# Product Change Notification

Product Change Notification: PCN-26-290294

EP2.5 DTV housing

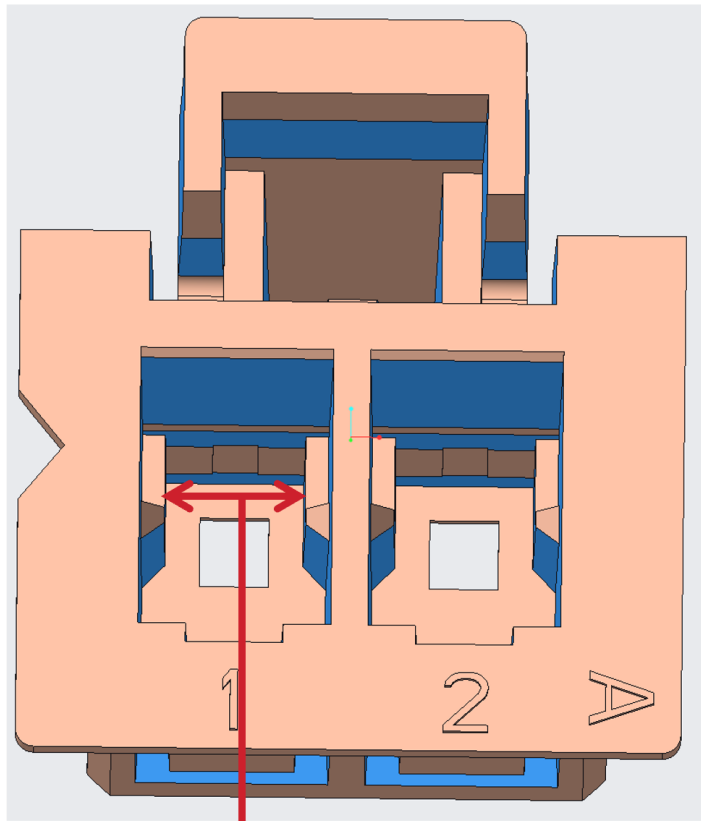
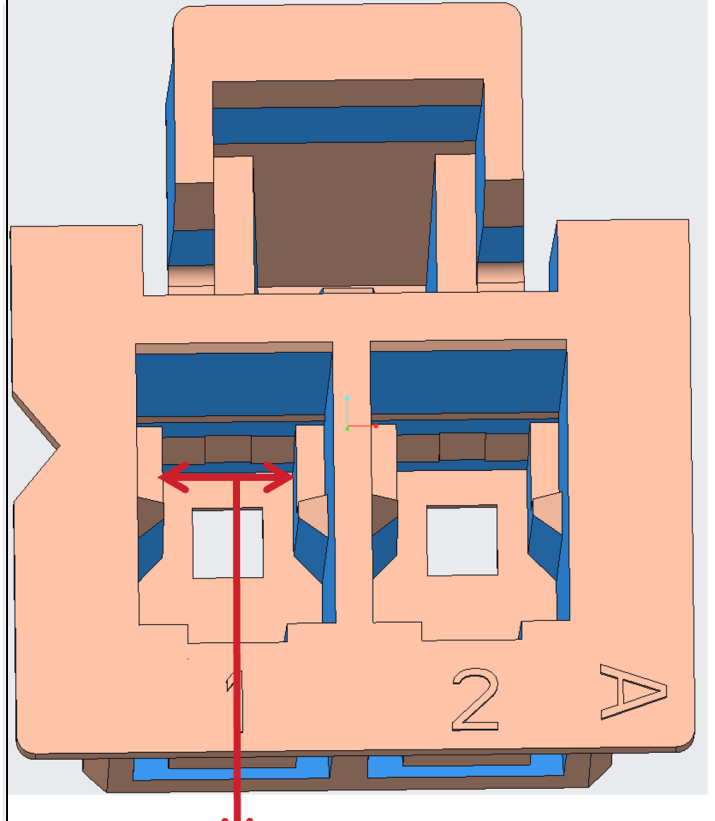
Please be aware of an upcoming feature change to the listed part numbers. Before: the slot width is 1.60mm/1.5mm After: the slot width is 1.40mm Reference performance test data:TP-26-01640

Update made to improve customer problem: Terminal incorrect insertion into housing

The slot width is 1.40mm.

1.40mm
